**ADDENDUM NO. 2**

**KENDALLVILLE PUBLIC LIBRARY RENOVATION  
MAIN AND LIMBERLOST BRANCHES  
MSKTD Project No.: 8045  
May 9, 2025**

**KPL - First Floor Electrical Demolition Plan Unit "B"**  
1/8" = 1'-0"

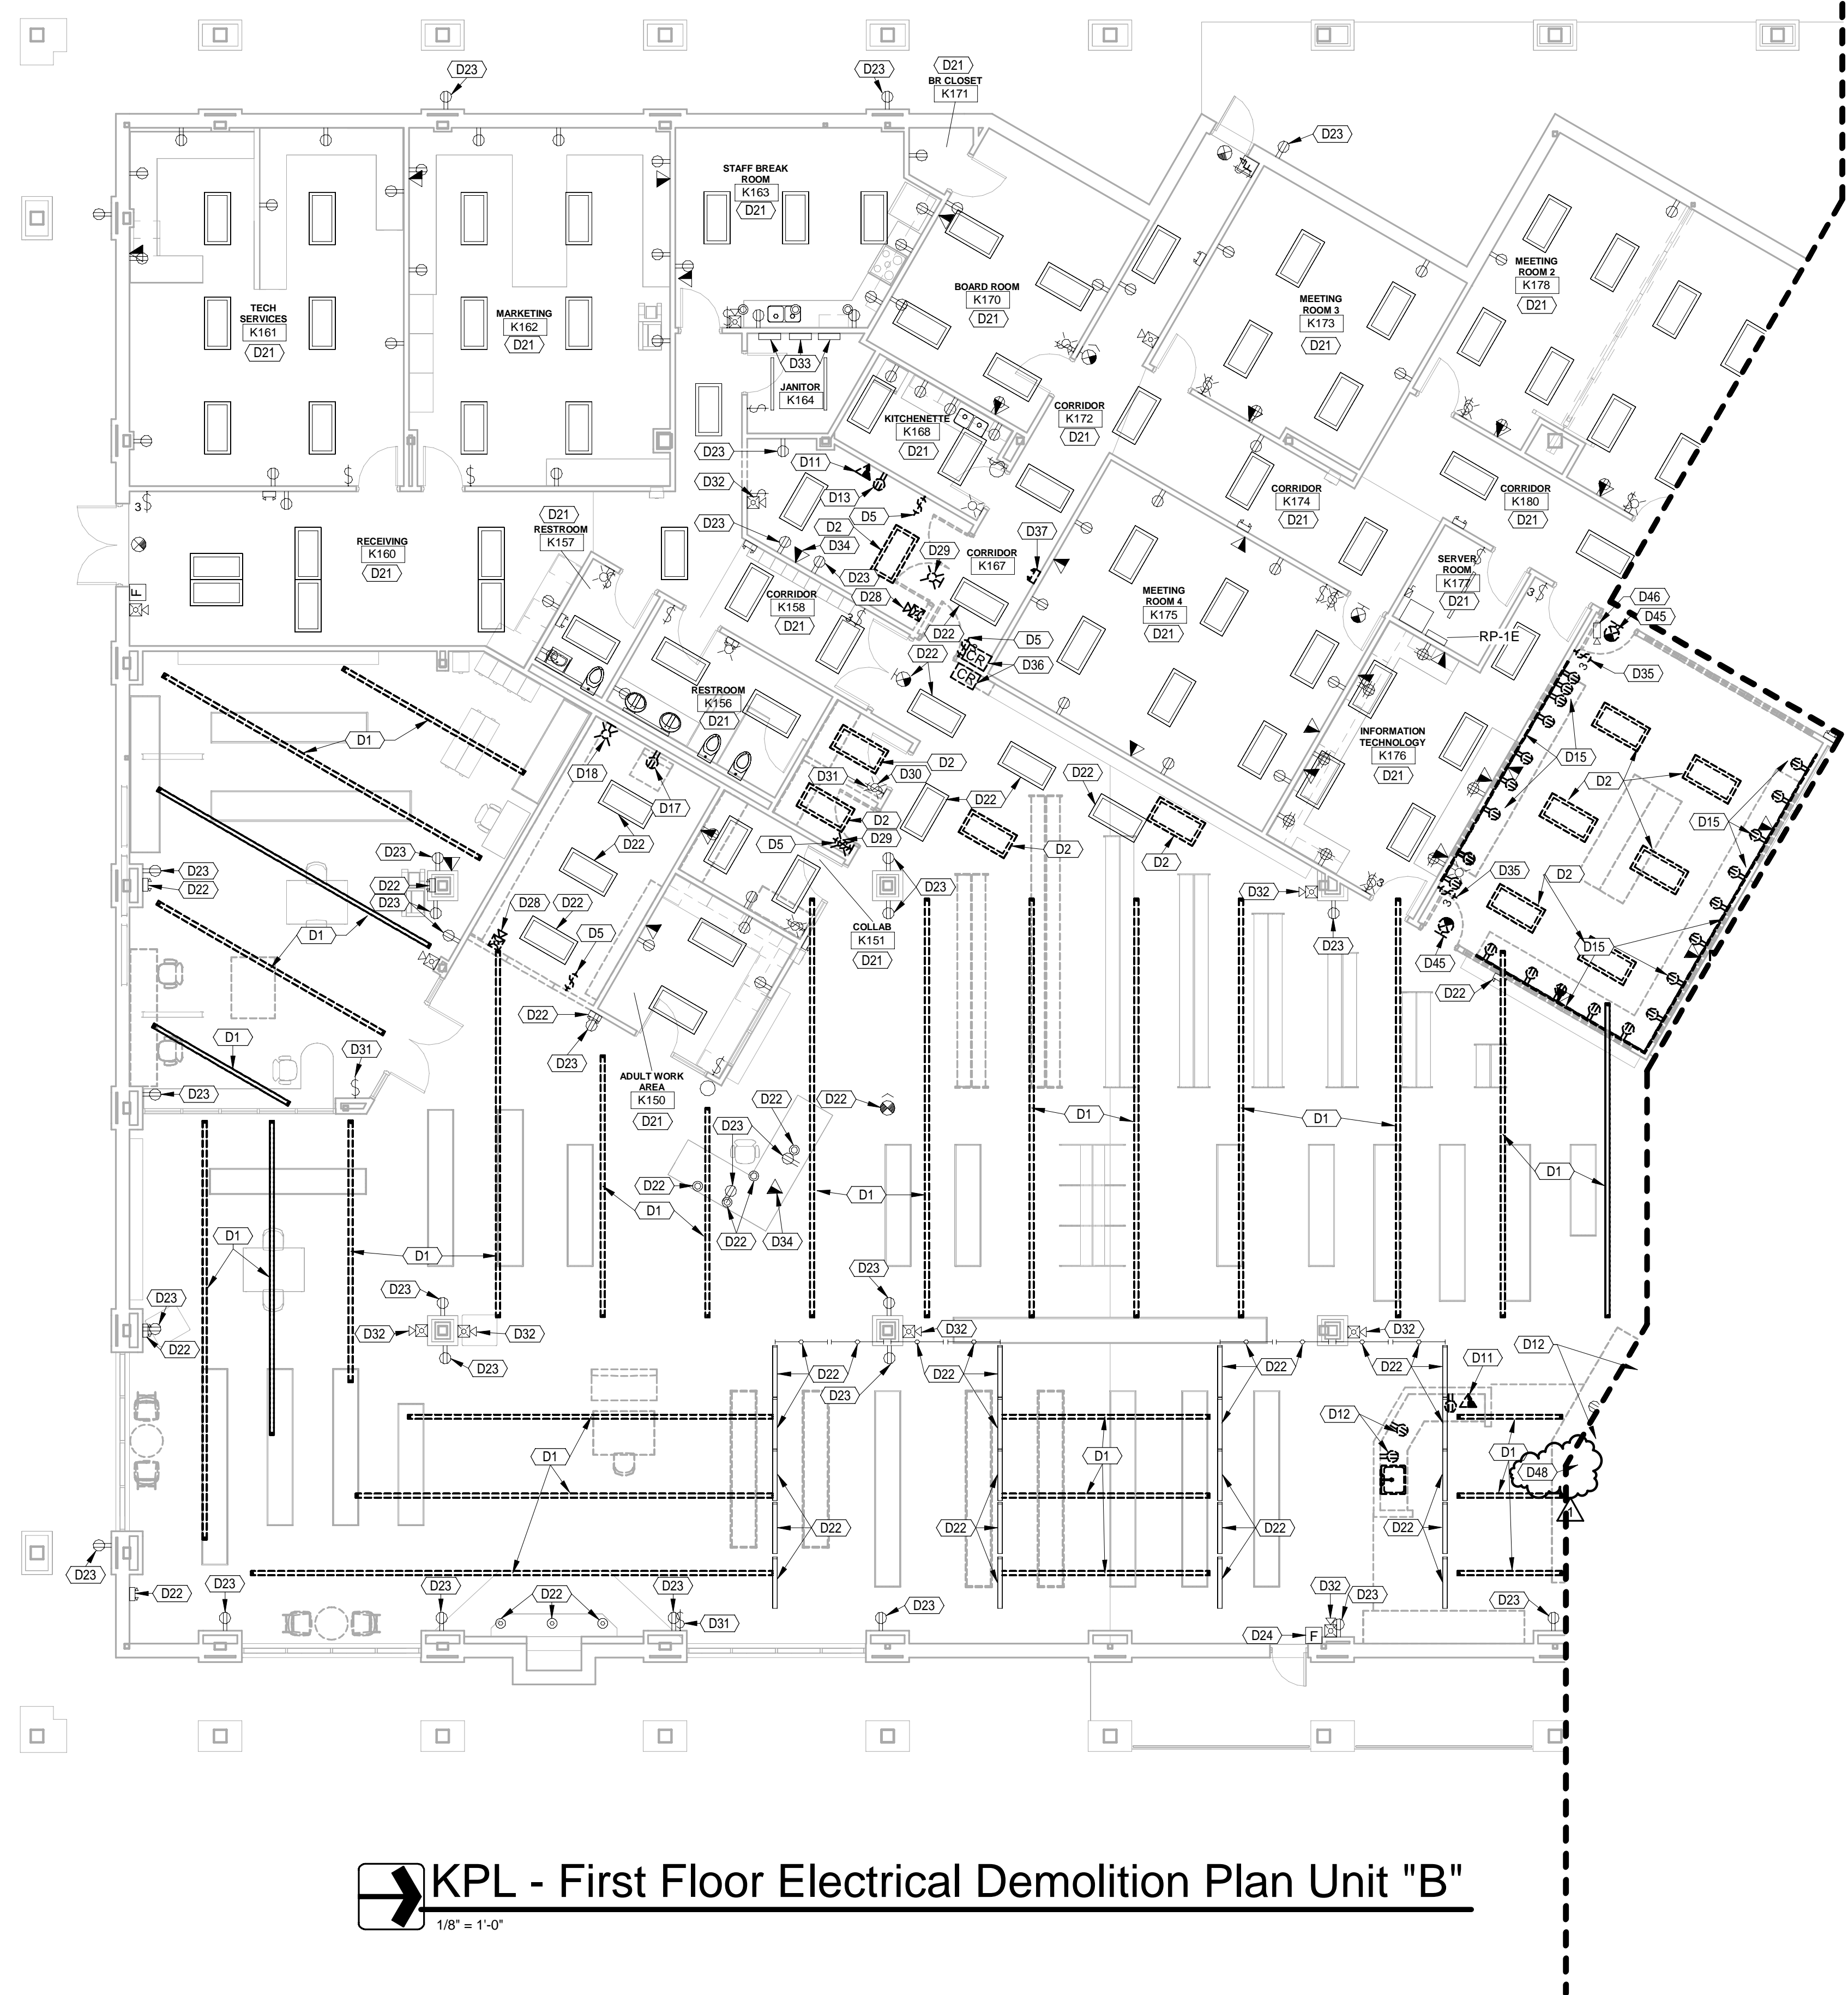
2.6	Drawings Sheet EK101b	<p>Refer to attached, revised sheet EK101b for the following clarifications/revisions:</p> <ol style="list-style-type: none"> <li>1. In Adult Stacks near Offices K170, show 1 EM light to be demo and add Demolition Plan note D48.</li> </ol>

- D48 DISCONNECT AND REMOVE EM LIGHT AND ASSOCIATED WIRING AND CONDUIT BACK TO JUNCTION BOX SOURCE IN ROOM. RETAIN EXISTING BRANCH CIRCUIT AS REQUIRED FOR CONNECTION TO NEW EM LIGHT FIXTURE. FIELD VERIFY EXACT CIRCUIT AND LOCATION. (TYPICAL)

**KPL - Lower Level Electrical Power Plan**  
1/8" = 1'-0"

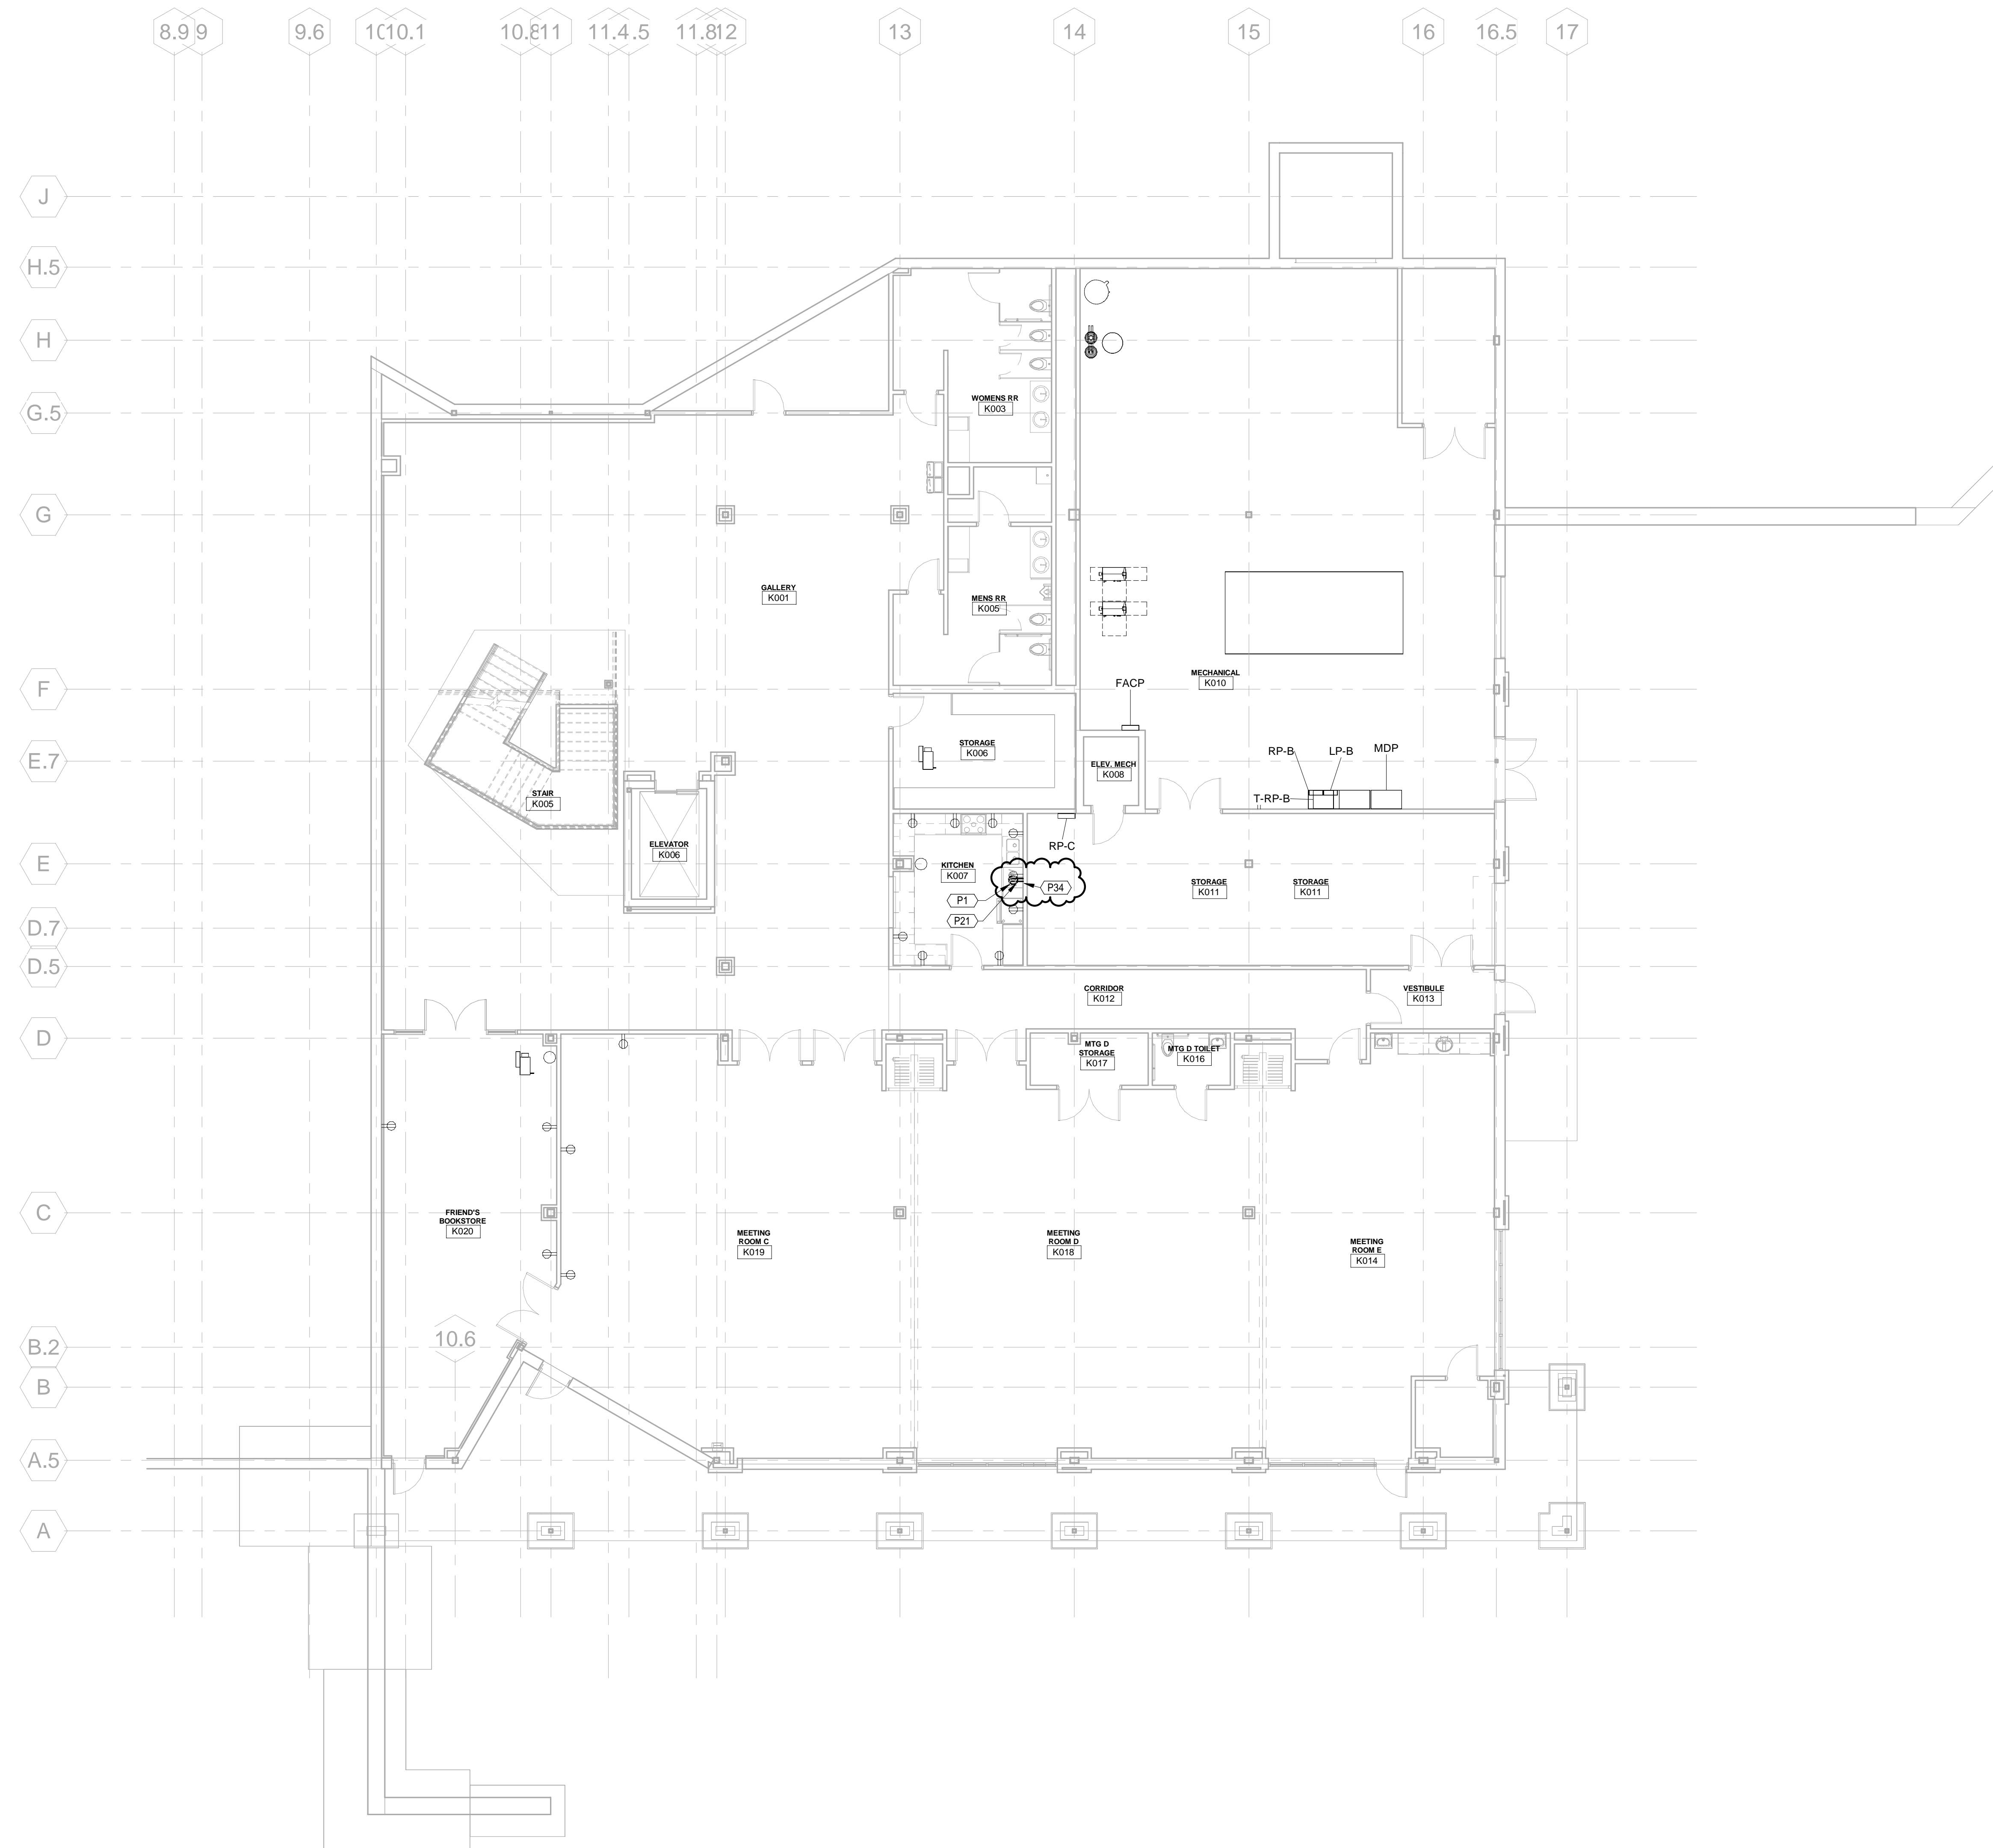
2.7	Drawings Sheet EK200	<p>Refer to attached, revised sheet EK200 for the following clarifications/revisions:</p> <ol style="list-style-type: none"> <li>1. In Kitchen K007, show added plan note P34. Add Power Plan note P34 to sheet.</li> </ol>

Power Plan Notes	
P1	MOUNT GFCI RECEPTACLE IN WALL BELOW COUNTERTOP IN CABINET FOR DISHWASHER.
P21	CUT, PATCH, AND REPAIR EXISTING WALL AS REQUIRED TO MOUNT NEW DEVICE FLUSH AND CONCEAL NEW CONDUIT IN EXISTING WALL. PROVIDE ALL WIRING IN CONDUIT AND CONNECT TO EXISTING ELECTRICAL SYSTEM.
P34	CIRCUIT TO NEAREST SPARE 20A/1P BREAKER IN 120V POWER PANEL. LABEL CIRCUIT ON PANEL LEGEND.

**KPL - First Floor Electrical Power Plan Unit "A"**  
1/8" = 1'-0"

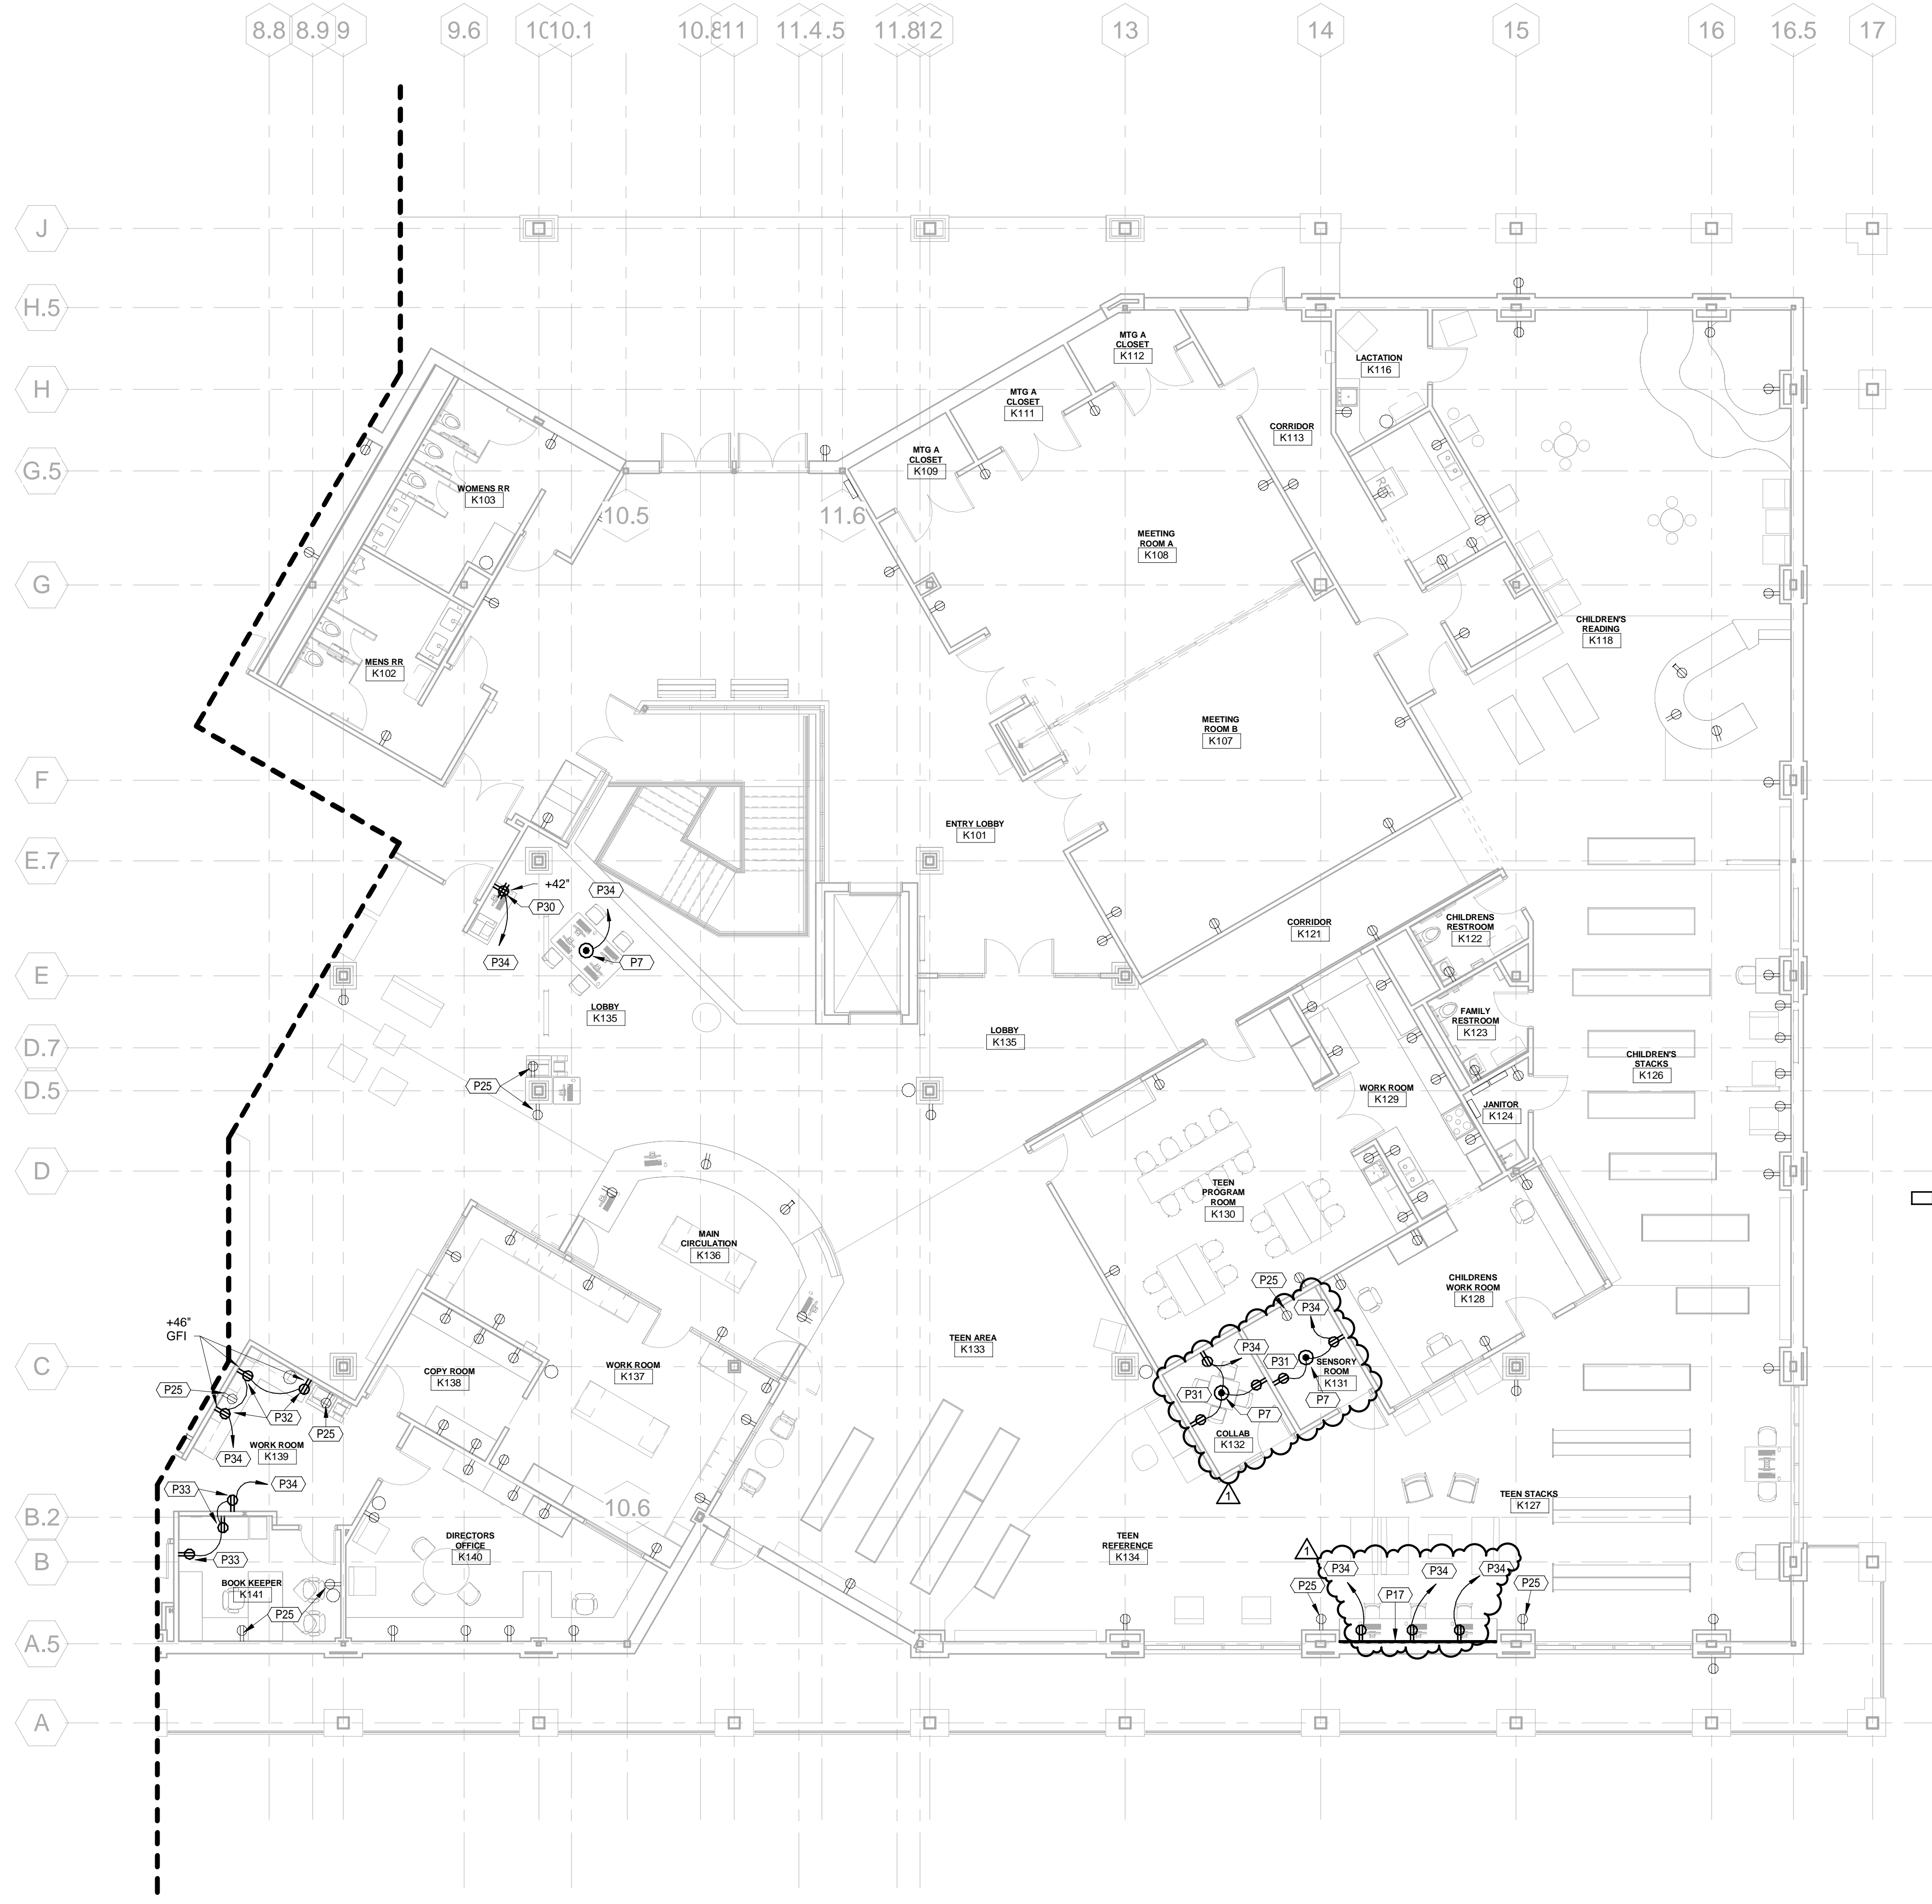
2.8	Drawings Sheet EK201a	<p>Refer to attached, revised sheet EK201a for the following clarifications/revisions:</p> <ol style="list-style-type: none"> <li>1. In Teen stacks K127, show circuits for outlets on east wall.</li> <li>2. In Collab K132 and Sensory room K131, show circuits for outlets.</li> <li>3. Added plan note P34 to sheet.</li> </ol>
